# State Significant Development Modification

PROPERTY: 4 Winchelsea Way, Terranora  
OUR REF: 230446  
DATE: October 2024

Document title:	State Significant Development Modification Report
Author:	Damian Chapelle
Project manager:	Damian Chapelle
Proponent:	Winchelsea Way Pty Ltd
Date of issue:	October 2024
Project address	4 Winchelsea Way, Terranora
Property Description	Lot 1 DP 595863 Parish of Terranora County of Rous
Registered Owner	Tweed Shire Council
Applicant	Newton Denny Chapelle for and on behalf of the proponent
Local Authority	Tweed Shire Council

Plate 6: Approved Subdivision Layout

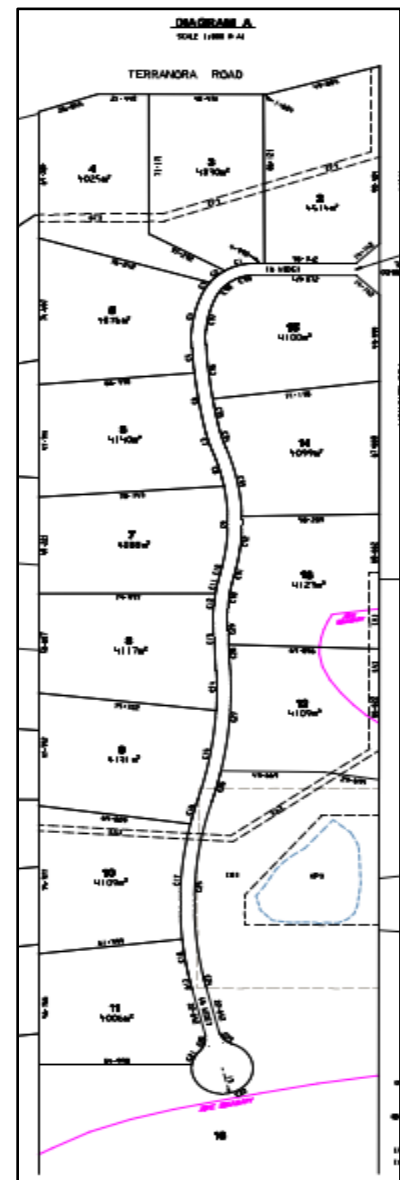
The proposal seeks to amend the approved lot layout to reflect the modified internal road width which accords to the NSW planning for Bushfire Protection Guidelines 2019.

The amended layout retains the originally approved number of lots, however provides for eleven (11) lots on the western side of the modified internal road. The modified layout ensures all lots adhere to the prescribed minimum lot size, whilst increasing the land area of the residue lot (Lot 16) from 9.48 hectares to 10.051 hectares.

In regard to proposed Lot 12, reference is made to the reduction in the easement for water supply (DP 617477) area which surrounds the existing dam as illustrated on B&P Survey 'Proposed Subdivision Plan', dated 29 April 2024 (refer **Attachment 2** of this report). The benefitted parties have provided their landowner's consent to the proponent, as contained within **Attachment 9** of this report for the reduction in the easement area. An adjustment to the configuration of the dam will also be included as part of this process and subject to a Stormwater Management Plan as included within **Attachment 3** of this report.

Further reference is made to the minor adjustment of each approved lot through the adherence of the community title lot being reduced in width to accord with the Planning for Bushfire Guidelines (2019) as outlined below in Section 4.3 below.
